Subject: **GEOTECHNICAL REPORT
PROPOSED DEVELOPMENT
4270 EAST MERCER WAY
MERCER ISLAND, WASHINGTON**

**Subject: ADDENDUM LETTER – RESPONSE TO 3RD PARTY REVIEW
 PROPOSED DEVELOPMENT
 4270 EAST MERCER WAY
 MERCER ISLAND, WA**

**Subject: ADDENDUM LETTER – RESPONSE TO SEPT. 4, 2019 REVIEW
 PROPOSED DEVELOPMENT
 4270 EAST MERCER WAY
 MERCER ISLAND, WA**

**Subject: PLAN REVIEW AND RISK STATEMENT
PROPOSED EAST HOUSE
4270 E. MERCER WAY
MERCER ISLAND, WASHINGTON**

Attached: Appendix B – Slope Stability Analyses Results (amended with legend)

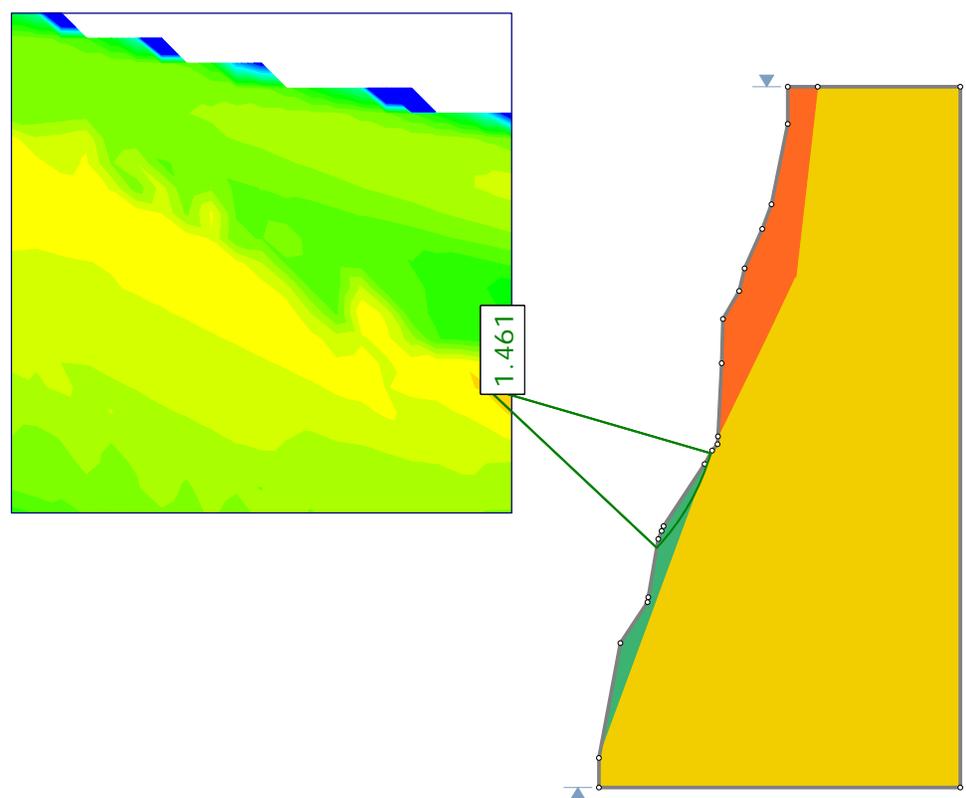
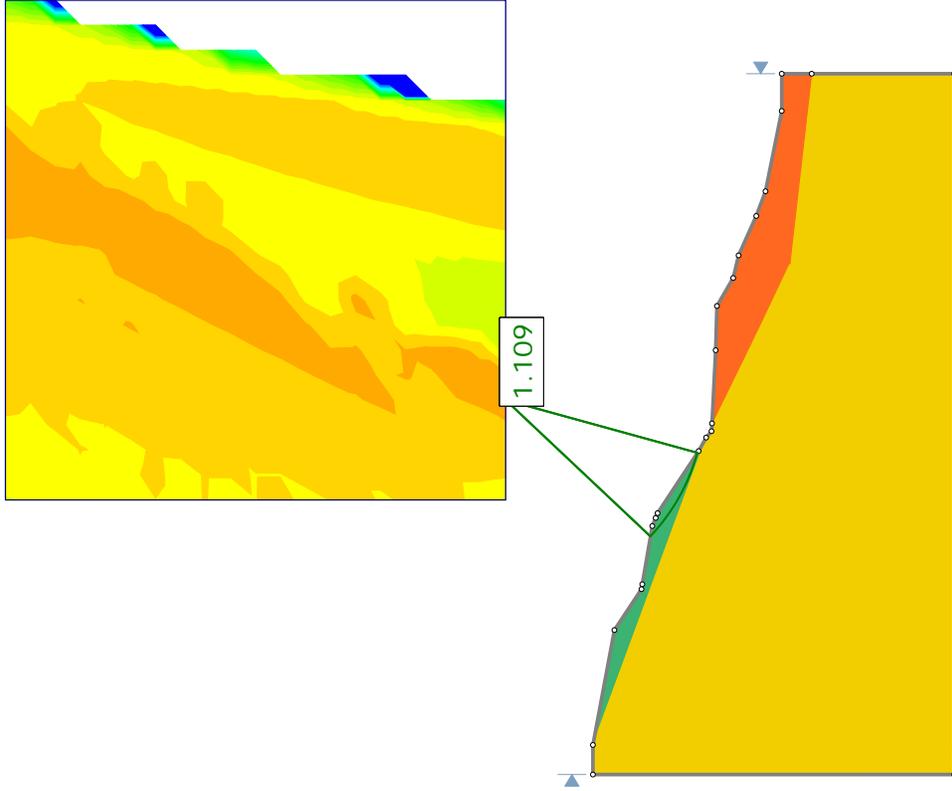
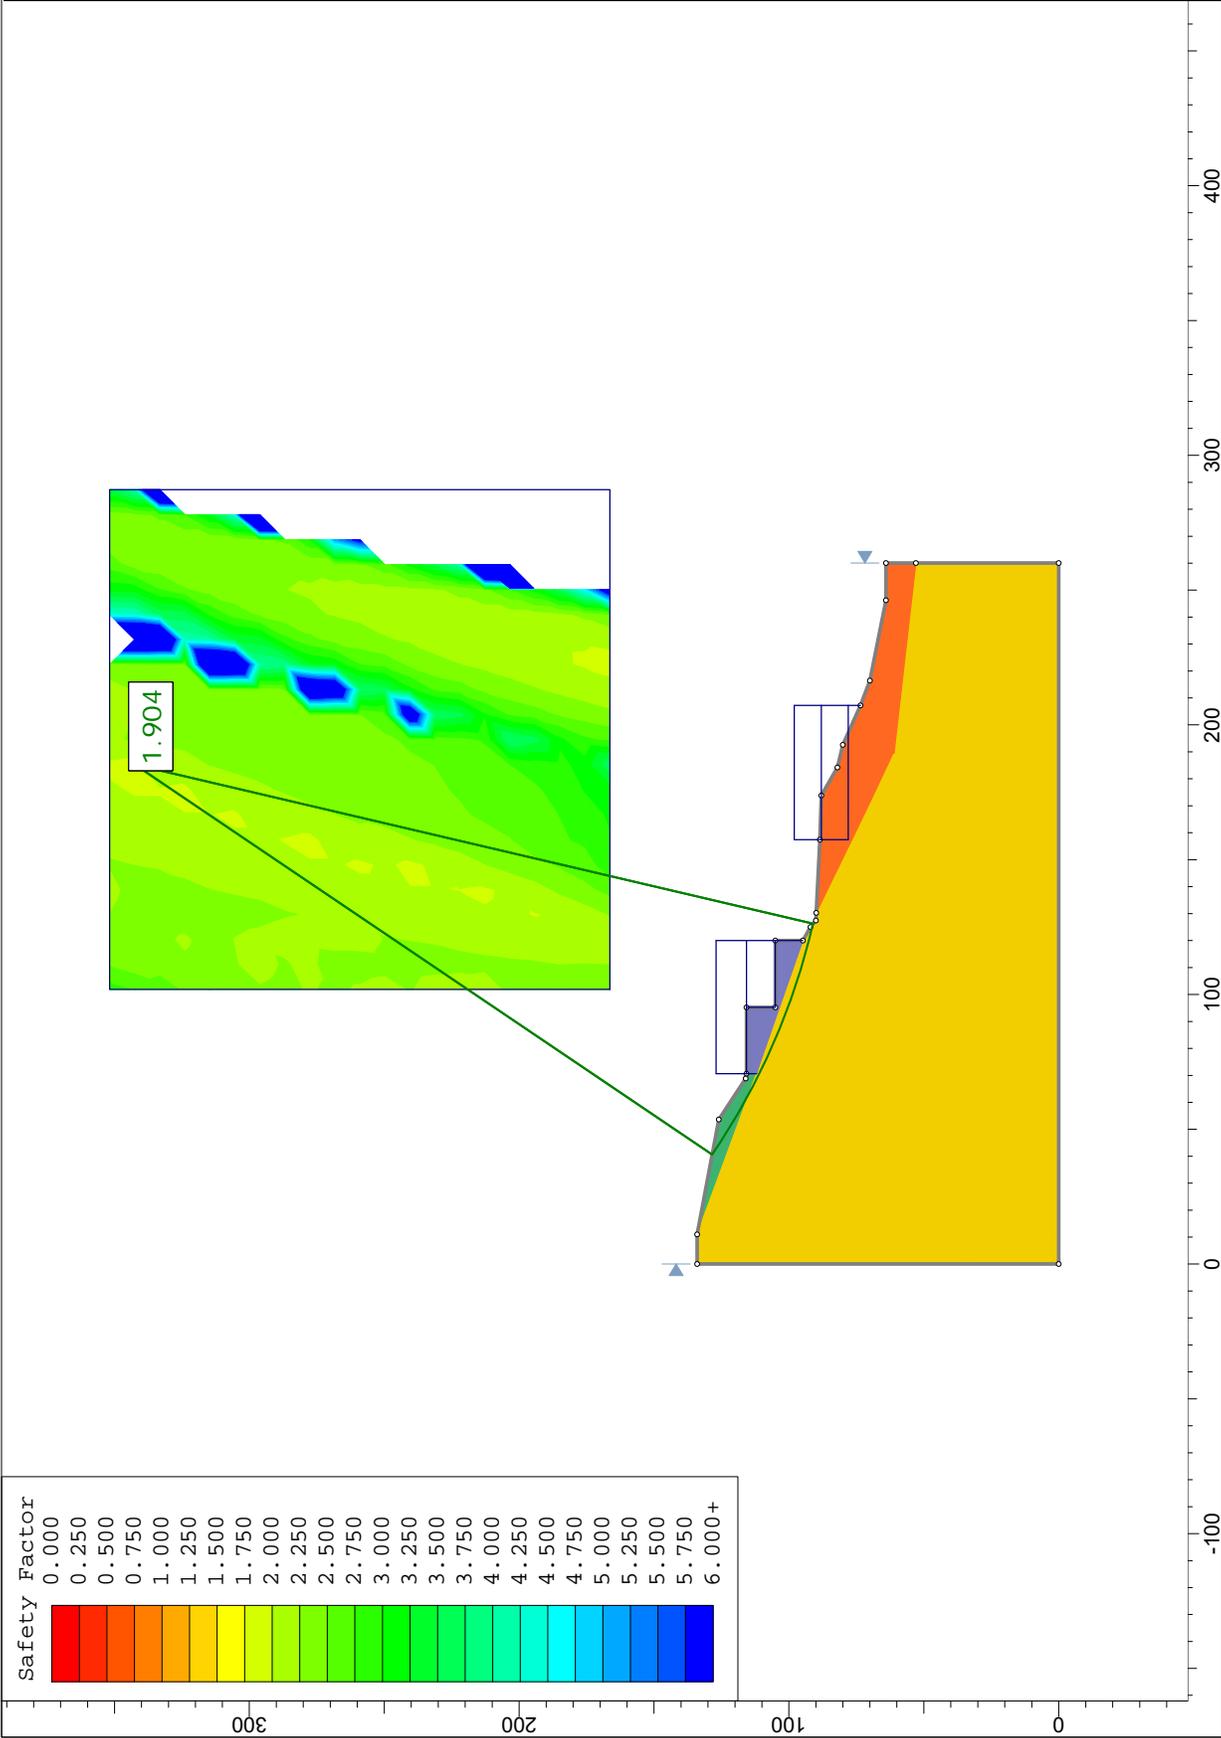
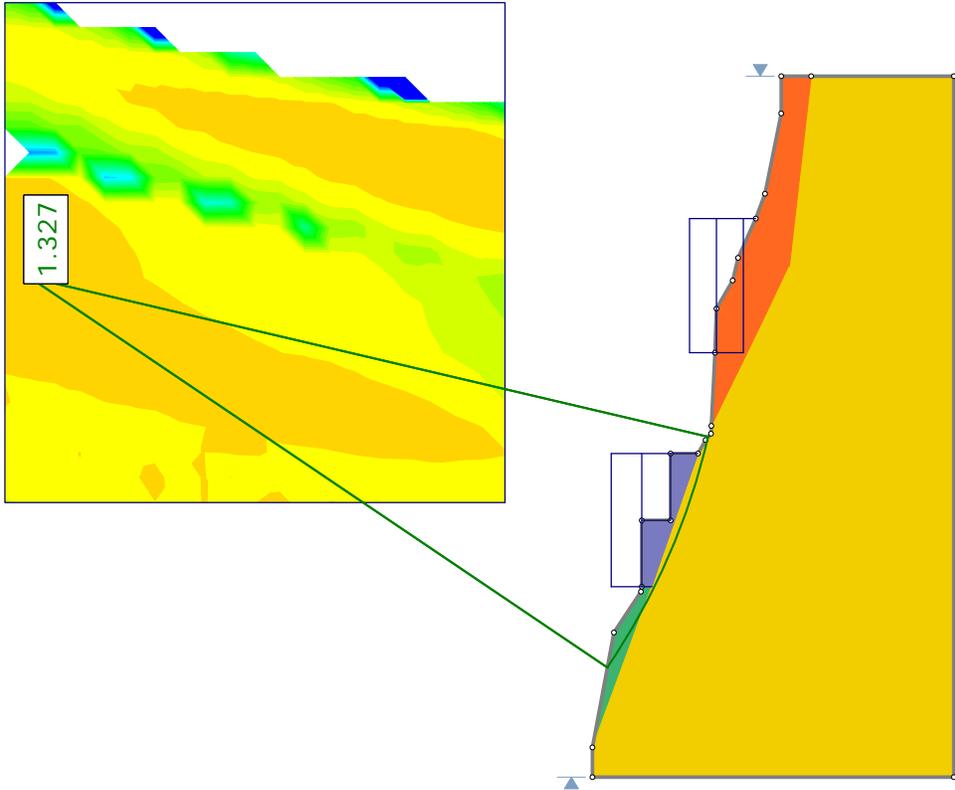
Provide a legend on stability models detailing the soil layer coloring and pertinent soils parameters.

analysis does not appear to include surcharge loading from the structural fill placed above existing grade. Please clarify whether structural fill was modeled in the analyses for the over-excavation and replacement option discussed, and whether surcharge from the structural fill was included.

Response #8:

Please see the attached amended Appendix B plots which show the structural fill soil unit and parameters used in the analyses. Note that the structural fill was given a unit weight such that the structural fill weight is accounted for in the stability calculation.

| PLATE: B |

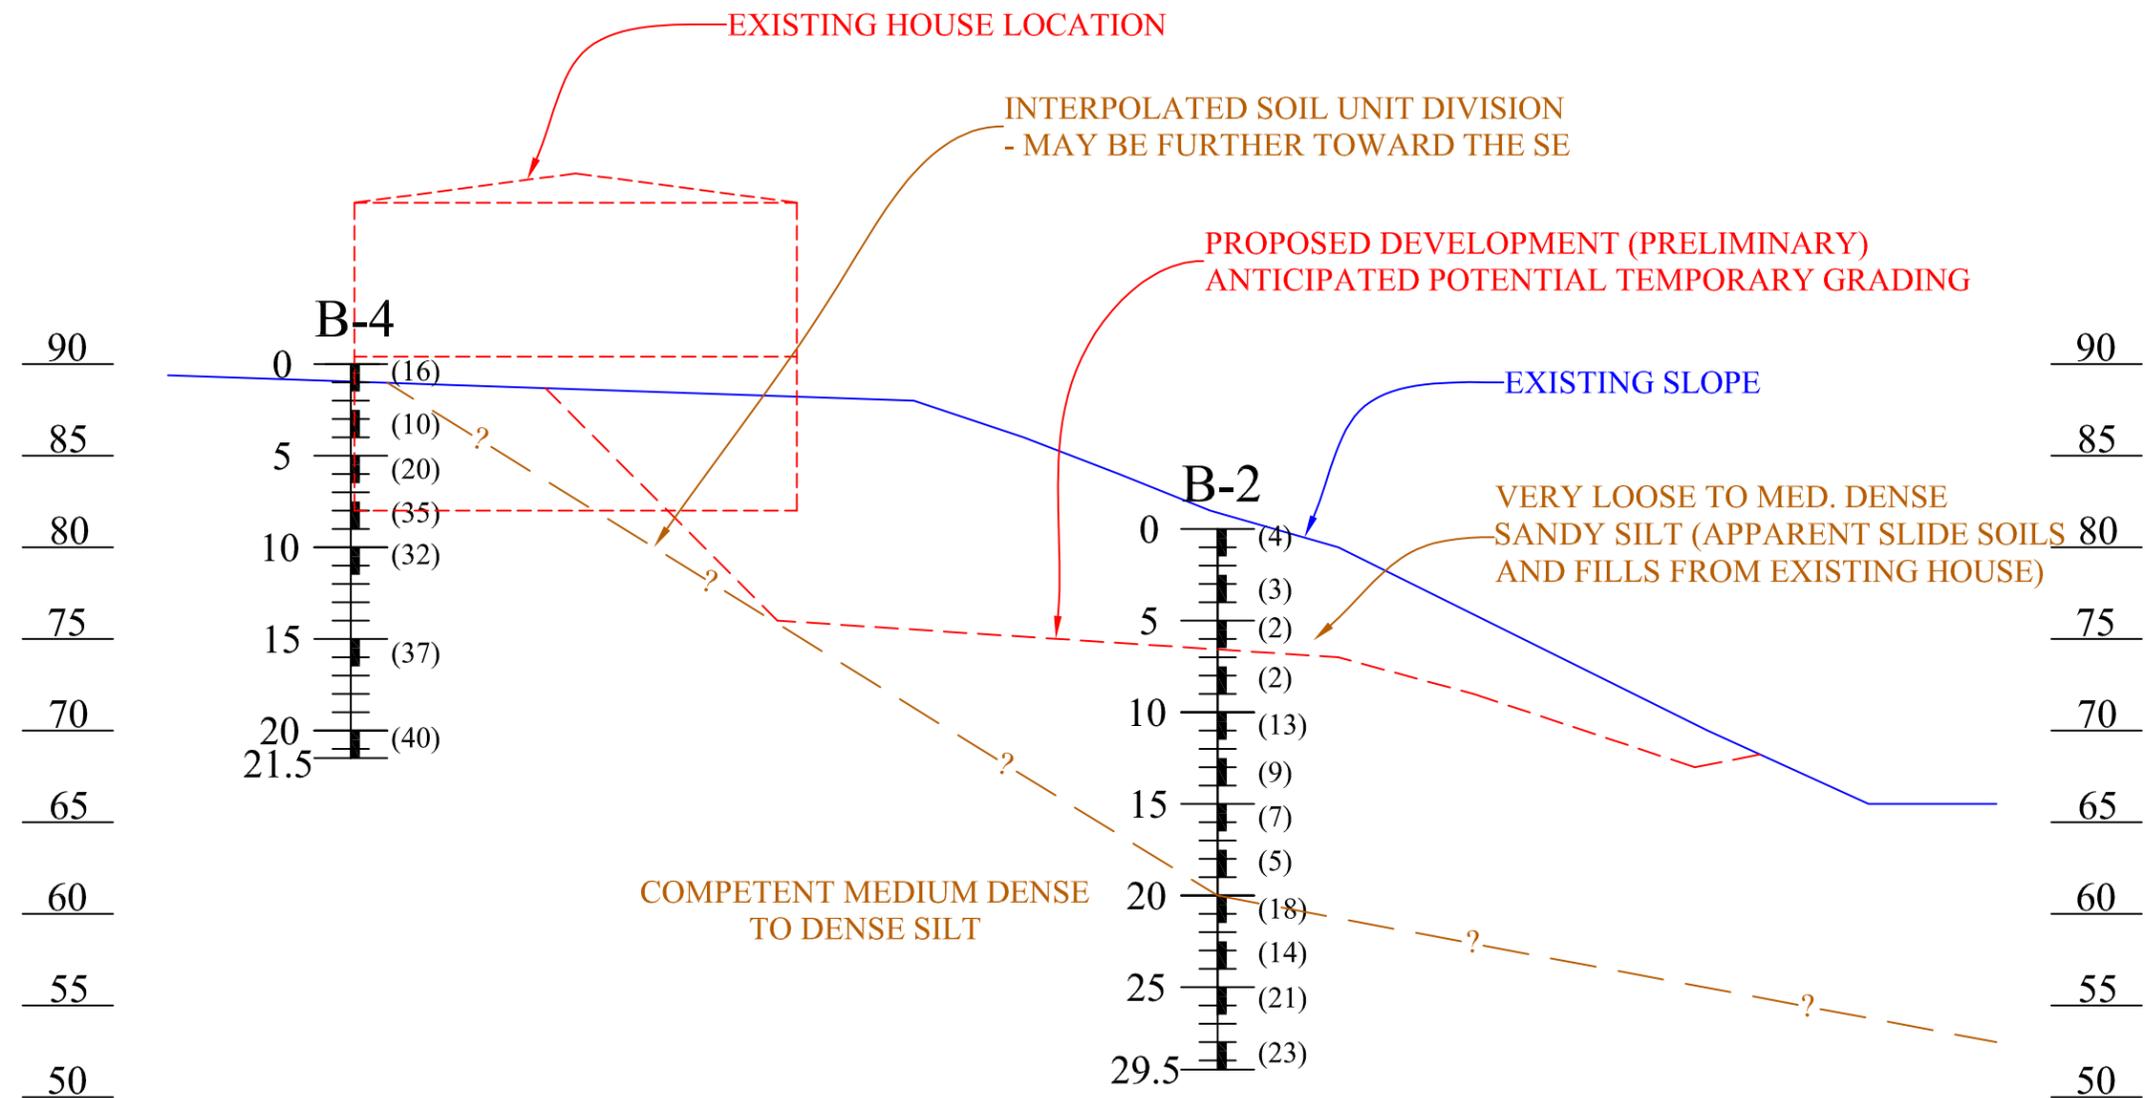
- c. Please explain the basis for an apparent cohesion value of 85 pounds per square foot. State whether apparent cohesion was used in both static and seismic loading conditions. If so, provide justification that apparent cohesion values should be used for the seismic loading case.

- d. Soil friction angles on Page 4 of the geotechnical report are the same for the near-surface sandy SILT in the upper slope and the “apparent slide soils” in the lower slope. Typically, landslide deposits are modeled using a residual or fully softened strength. Referring to Comment 1a, please confirm that the “apparent slide soils” are not cohesive and therefore, do not require residual or fully softened strength parameters.

It is also important to note that preliminary planning for the proposed lower building pad will presumably remove a significant portion of the overlying loose apparent colluvium (old). The attached **Plate B – Cross Section B – B'** illustrates that the excavation into the slope for the new building will remove significant driving force at the top of the lower slope area.

| | Analysis Description PROPOSED TEMPORARY SLOPE CONFIGURATION- B - B' | |

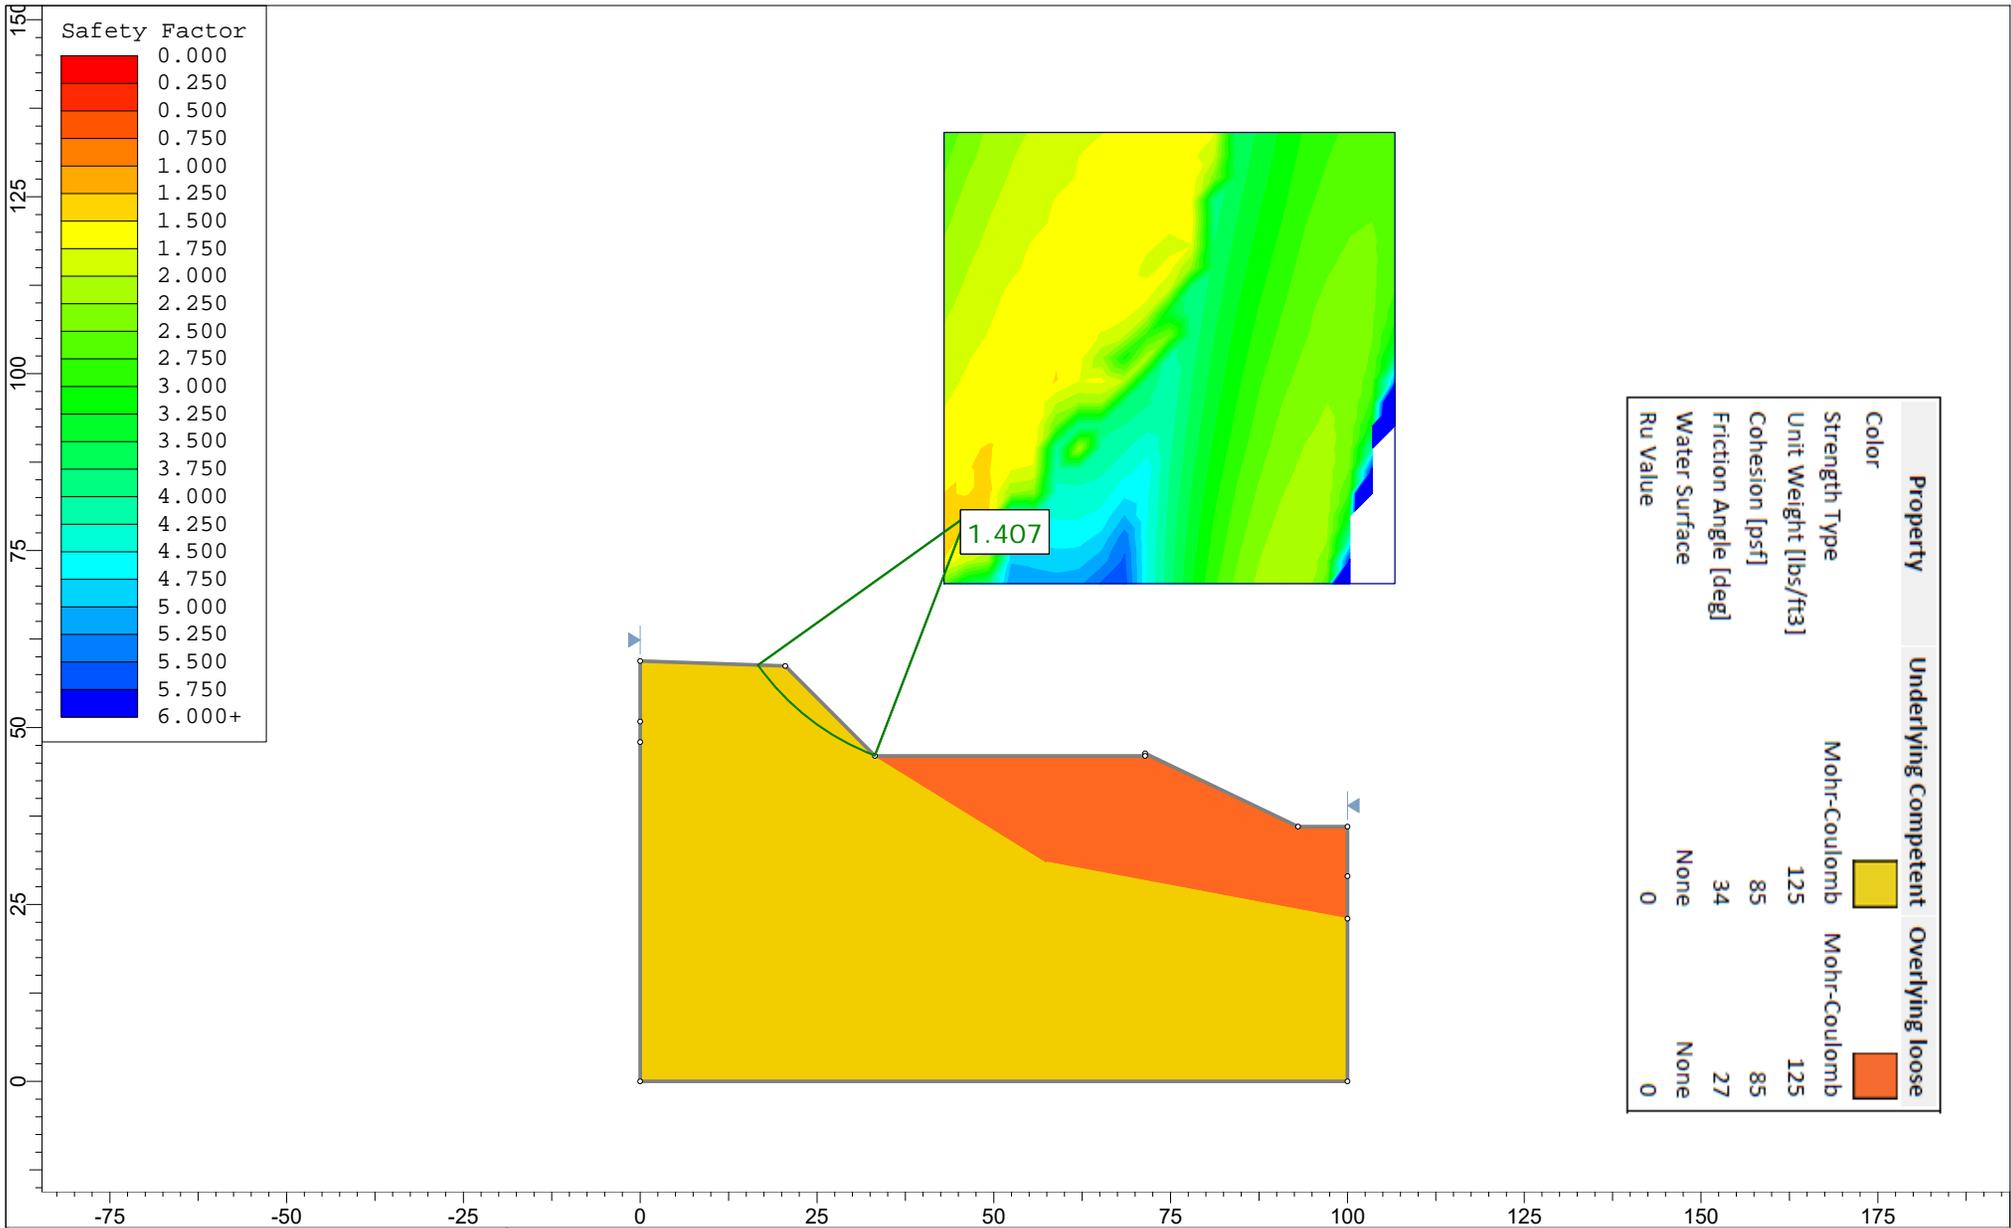
There is an obvious transition between the subsurface conditions in boring B-4 to B-2. If open cuts are planned in the lower house excavations, provide stability analyses that will indicate a sufficient factor of safety against slope instability, using subsurface conditions encountered in boring B-2 and an assumed groundwater elevation. Alternatively provide recommendations for a temporary shoring system for the lower house excavation or specific recommendations on construction sequencing or other measures that could be taken to maintain short-term stability of the slopes.

Response #10:
